Sub: Diversion of 12.25 ha Protected Forest land for road widening of existing Visnagar-Vijapur road SH-130 in Ta-Visnagar & Vijapur in favour of Executive Engineer, Mehsana (R&B) Division in Mehsana District of Gujarat.

Government of India  
Ministry of Environment, Forest & Climate Change  
Regional Office (WZ), Bhopal.  
40<sup>th</sup> Meeting of Regional Empowered Committee, Bhopal  
Dt. 14/11/2019

MINUTES OF MEETING

✓ **Diversion of 12.25 ha Protected Forest land for road widening of existing Visnagar- Vijapur road SH-130 in Ta-Visnagar & Vijapur in favour of Executive Engineer, Mehsana (R&B) Division in Mehsana District of Gujarat. 6-GJC047/2019-BHO**

DSS Image

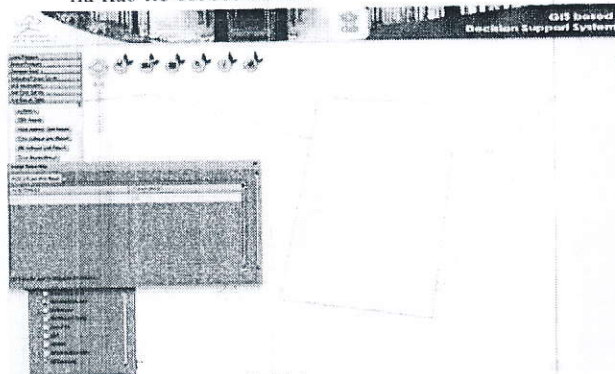
- 6) Geo-referenced digital maps of CA (Polygon map with DGPS coordinates) Submitted.
- 7) KML file of CA site in polygon shape to be uploaded online.
- 8) DSS analysis (proposed diversion land): The area cannot be calculated as the KML file of proposed road is in line format.

- 1) Toposheet map of CA wrongly uploaded on webportal, so correct Toposheet map of CA shall be uploaded.
- 2) Certified copy of online Part-I and Part-II shall be submitted.
- 3) As the project is crossing the railway line, NOC from Railway authority shall be submitted.
- 4) The KML file of proposed road for proposed widening in forest area excluding blacktop road shall be submitted.
- 5) The Certificate of Collector under FRA, 2006 for proposed CA land as per Para 6.3e (ii) of Forest Conservation (Rule), 2003 (Amended upto August 2017).
- 6) Details of site specific CA :
  - a) Saplings to be planted (Minimum standard height and collar girth species wise).
  - b) Soil & moisture conservation works.
  - c) Regeneration cleaning.

3. As the project is crossing the railway line, NOC from Railway authority shall be submitted.
4. The proper KML file of proposed widening of road in forest area excluding blacktop road shall be submitted.

Google earth image of CA land

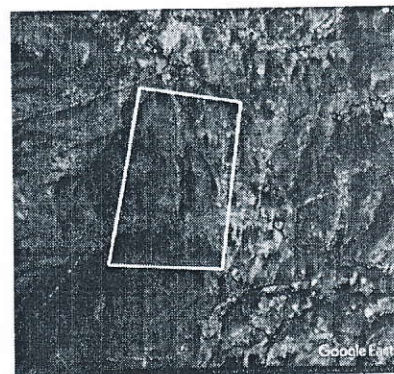
- 9) DSS analysis (proposed CA land): 25.64 ha and out of that 2.00 ha open forest & 23.00 ha has no forest cover.

5. The CA land shows encroachment / agricultural fields, thus CA land should free form all incumbencies.
6. The revised site specific CA scheme shall be submitted as per the Para 2.8(iii) of FCA Handbook 2019 and including following points:
